## Service Bulletins

BULLETIN NO : SBMA200314  
BULLETIN TO : MARINE DEALERS  
DATE : September 2003  
SUBJECT : BF50 A4 engine stall / Hesitation during acceleration.

BULLETIN NO : SBMA200312 Addendum  
BULLETIN TO : ALL MARINE DEALERS  
ATTENTION : SERVICE MANAGER AND ALL RELEVANT STAFF  
DATE : May 2003  
SUBJECT : BF 175 / 200 / 225 Recall

## PRODUCT SAFETY RECALL BF175 • BF200A • BF225A MAIN ENGINE HARNESS INSPECTION

Transom drilling illustration.

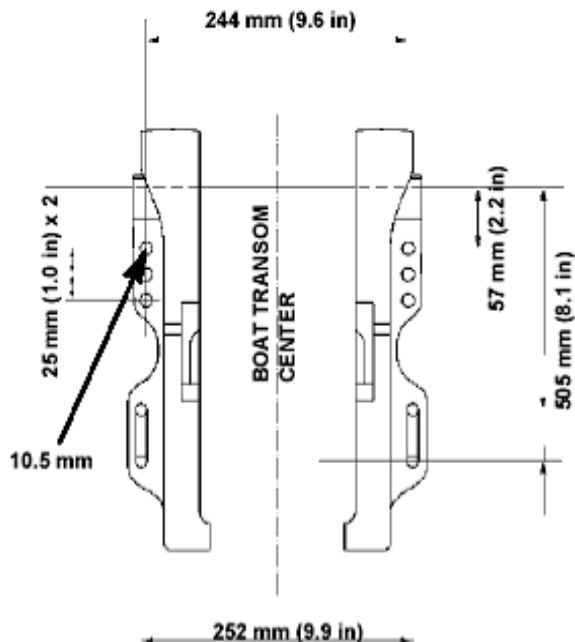
2/.Using the transom bracket on the outboard, mark four centre marks for the bolt holes on the transom board (two marks on either side of the outboard motor installation lines). Use highest holes in the upper bracket.

Be sure the upper bolt holes are not located above the position shown in the drawing, (less than 57 mm from the top of the transom.)

3/.The Lower bolt holes should be in the top of the bracket slots. Wearing safety glasses, drill pilot holes using a 3-5 mm drill bit. Finish drilling the holes using a 10.2 mm drill bit.

Note; drill holes at right angles to the transom

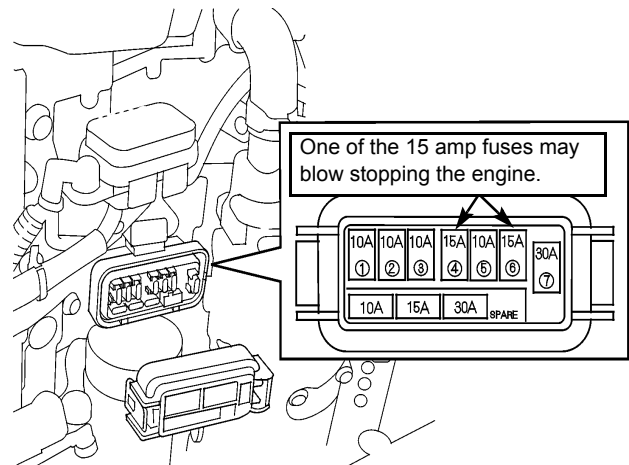
The routing of the engine wiring harness may allow contact with the throttle body under normal running conditions. Eventually, the repeated contact may wear through the wire's insulation and cause a short circuit. This may cause a blown fuse (15A) and the engine will stop, or the short may cause the throttle cable to overheat and become difficult to move or, in the worst case, the throttle could become stuck.

The throttle arm will not operate because the throttle cable inner liner has melted and cooled around the cable.

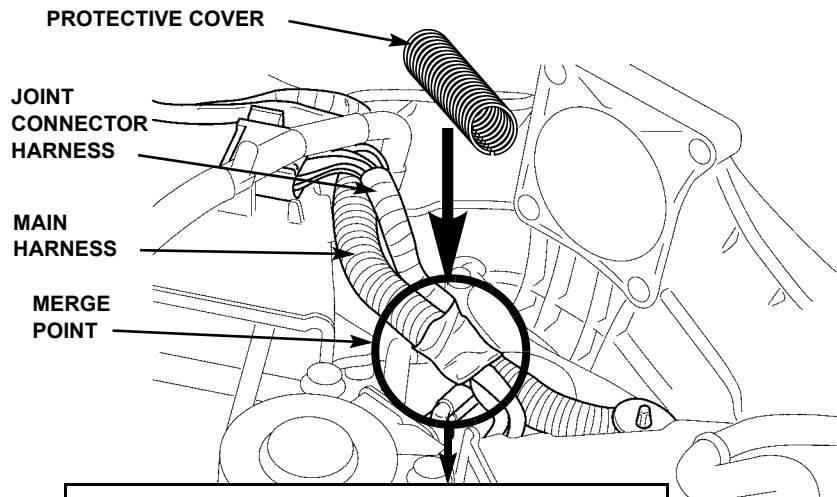
11. Inspect the taped area where the joint connector harness merges with the main harness. If any of the tape is rubbed or broken where any of the wires are visible, proceed to *Main Engine Harness Replacement* (page 6). If no damage is visible, continue on and install the protective cover.

Replace the main engine harness if the tape is rubbed, torn or damaged exposing any of the wires.

12. Install the protective cover over the main harness where the joint connector harness merges with the main harness.

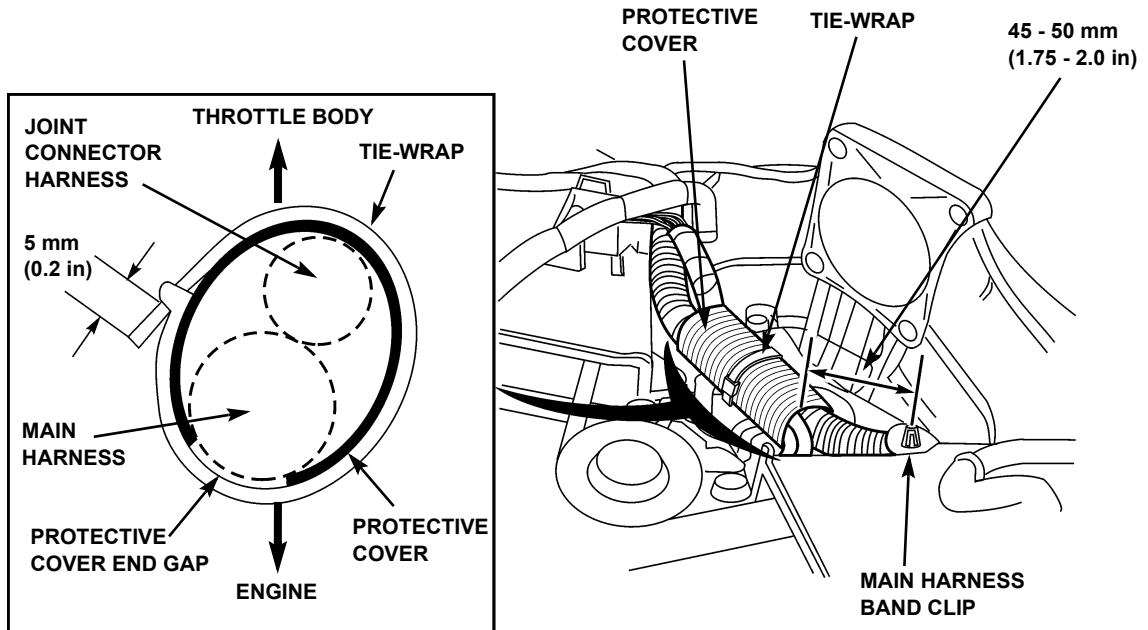
13. Make sure the protective cover gap is toward the engine and the closed end is toward the throttle body.
14. Position the end of the protective cover 45 - 50 mm (1.75 - 2.0 in) from the main harness band clip as shown.
15. Secure the protective cover to the main harness with the tie-wrap as shown. Cut the end of the tie-wrap to a length of 5 mm (0.2 in).

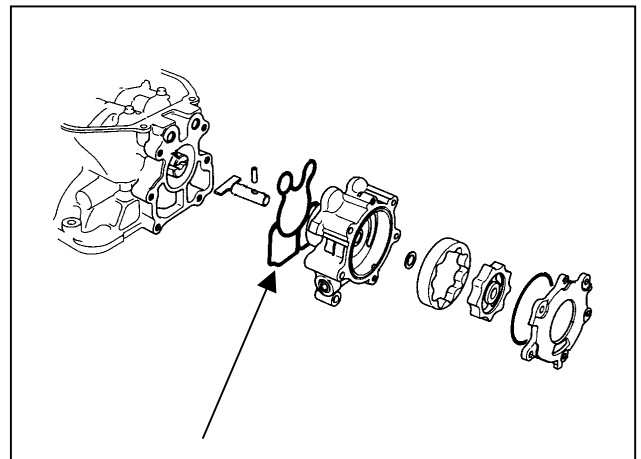
An engine oil may leak may occur from between the engine and mount case area.

During manufacturing a human error may have been made and the o ring may have been damaged.

Replace parts as per list below. Use the workshop manual for the correct assembly and disassemble procedure.

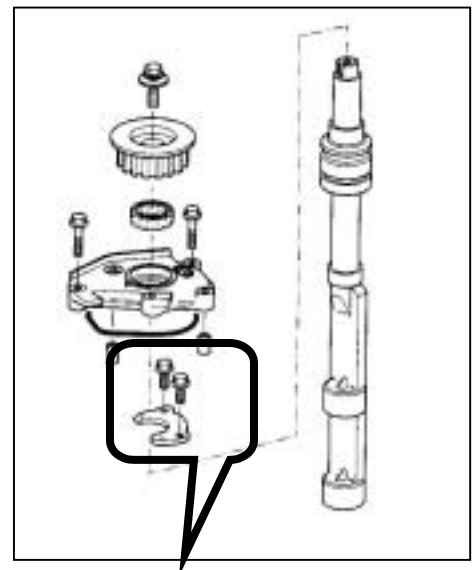
Oil may leak from the balancer shaft on the exhaust side of the cover.

During manufacturing a human error may have been made and the retaining plate and the two bolts may not have been installed.

Replace parts as per list.

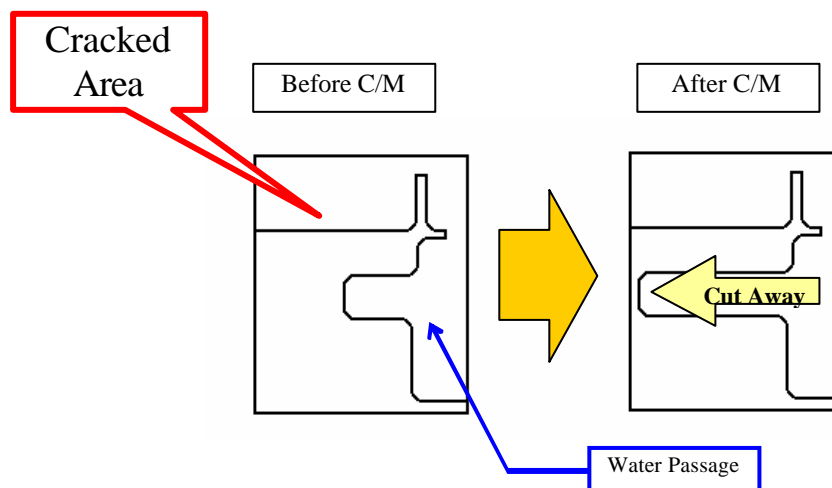
In order to avoid the concentration of stress the four reinforcement ribs in the exhaust port have been modified.

After C/M

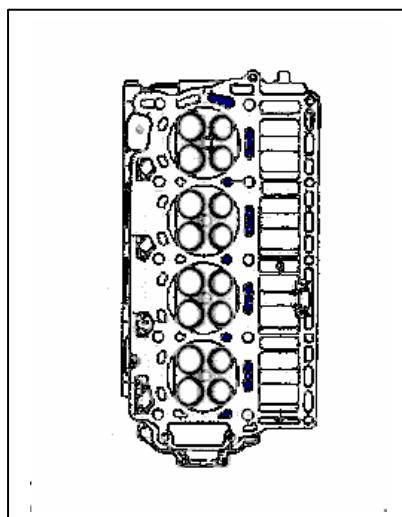
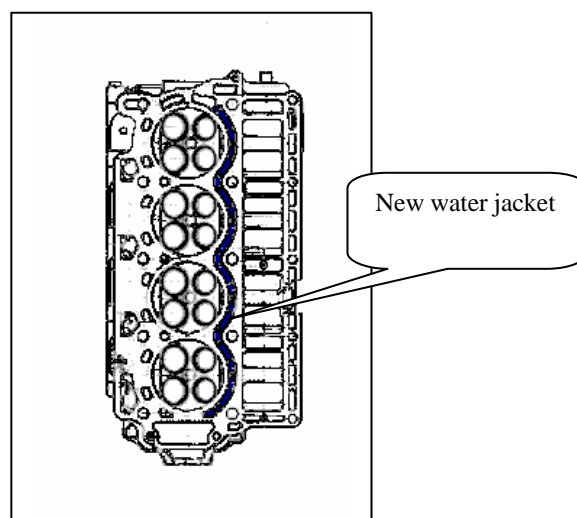
A cooling water jacket passage has been added in the cylinder head to help the engine have a more even flow of coolant water. The thermostat valve opening temperature has been changed from 72 to 60 degrees Celsius to reduce the coolant temperature.

**After replacement**  
**Note: fuel chamber angle**

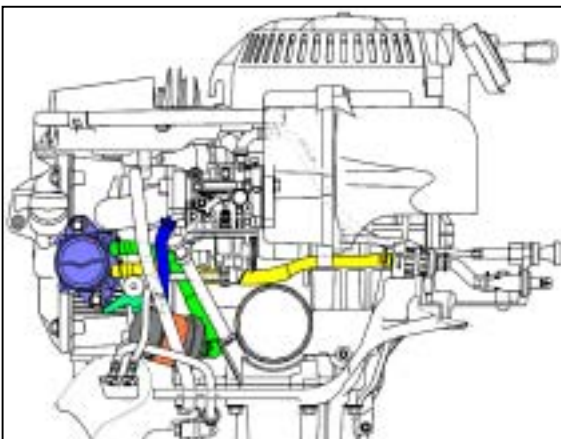
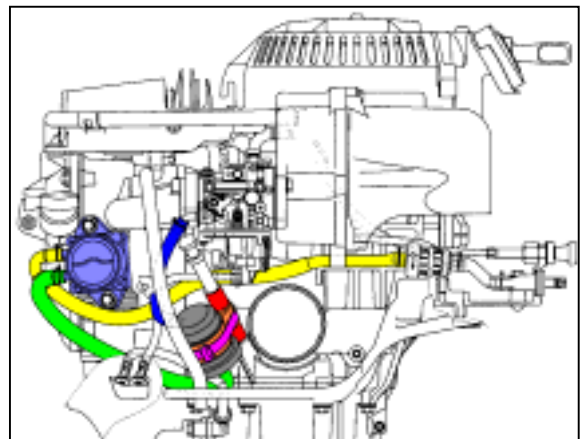
A small amount of fuel may leak out of the outboard under the following conditions.

1. The engine is stopped after wide open throttle operation.
2. The outboard motor is fully tilted up and tipped to the right-turn position and kept in that position for 1.5 to 8 minutes.

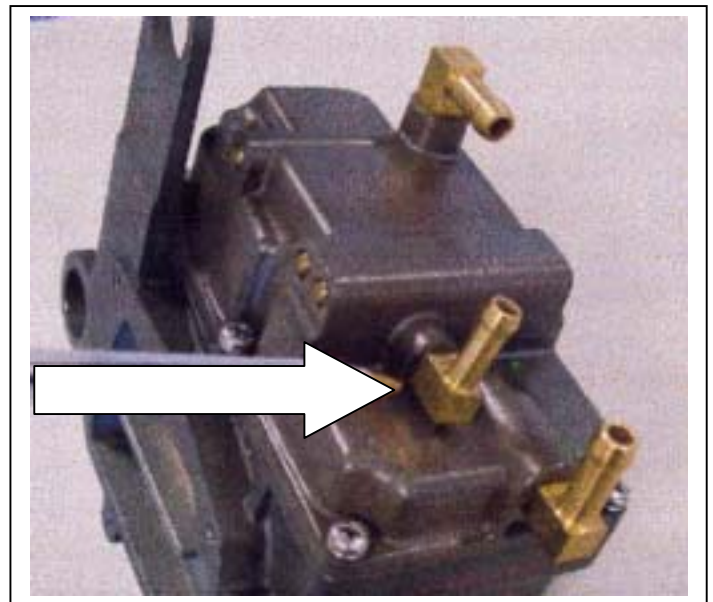
Insufficient machining of the fuel return joint.

Replace the vapor separator kit.

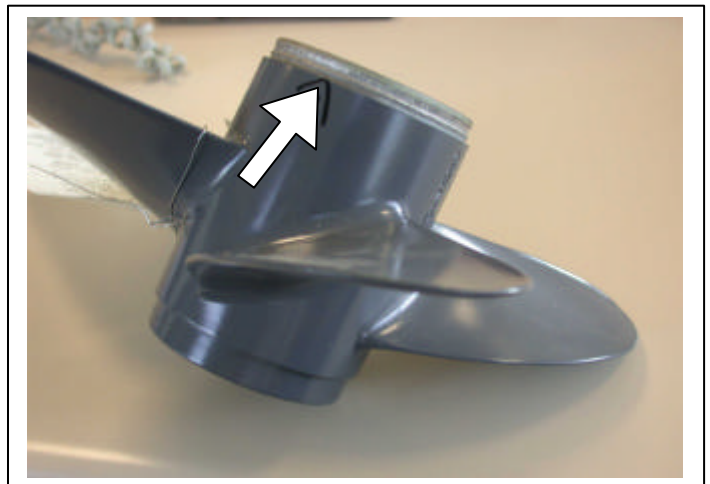
It has come to our attention that the propellers on the 8 and 10D may become damaged after a few hours of use.

Replace the propeller.

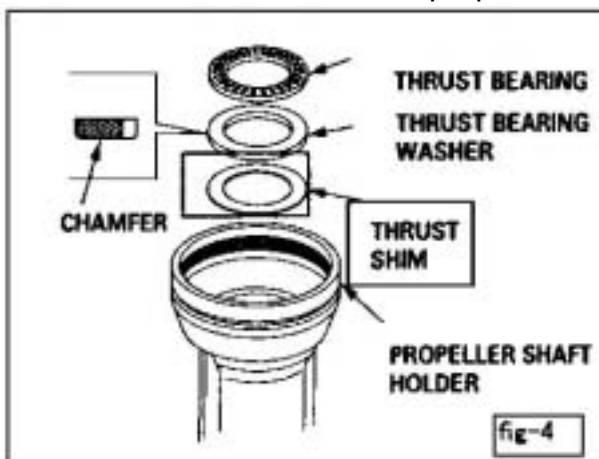
Due to excessive free play in the thrust direction of the propeller shaft, the forward bevel gear may leave the correct position in low-load conditions. At this time the gear may run in an incorrect contact position causing the gear teeth to take a large amount of stress.

**Step 3 :** Install the thrust bearing shim as per the diagram below fig -4.

**Step 4 :** Reinstall the bearing holder and tighten the torque to 191 Nm (19.5 kgm).  
Then make sure the propeller shaft turns freely in neutral position.

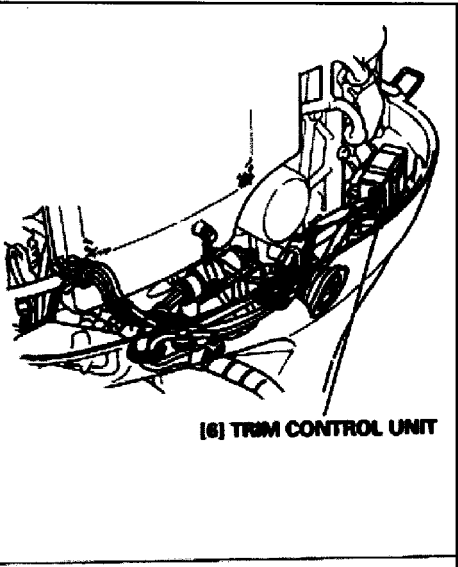
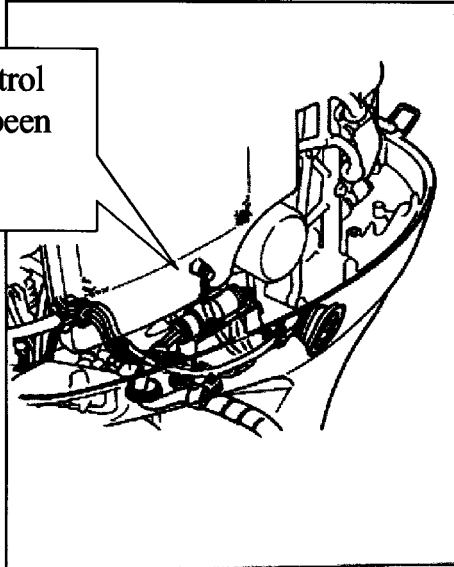
\* The new style control box starts from the frame numbers below.

BF 40 A2	BAYL-3221532 and subsequent
	BAYL-3100445 and subsequent
BF 50 A2	BAZS-3222752 and subsequent
	BAZL-3100576 and subsequent
	BAZU-3100088 and subsequent

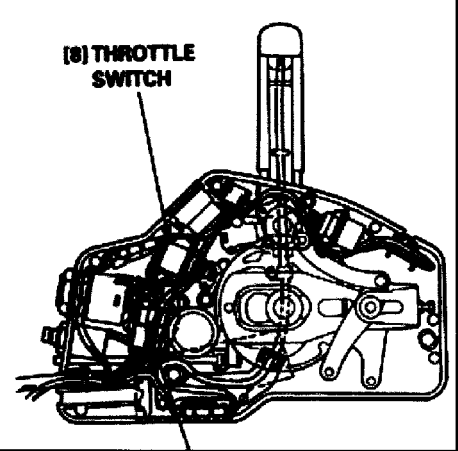
Trim control unit has been removed

Throttle position Switch has been removed

**The changes are shown below**

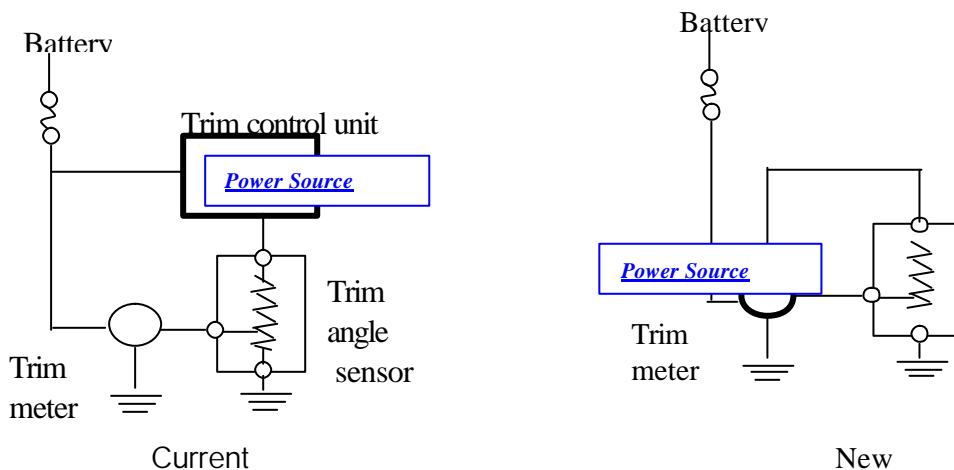
This also means that the throttle sensor switch has been removed and a 5 Volt output line added to power the meter.
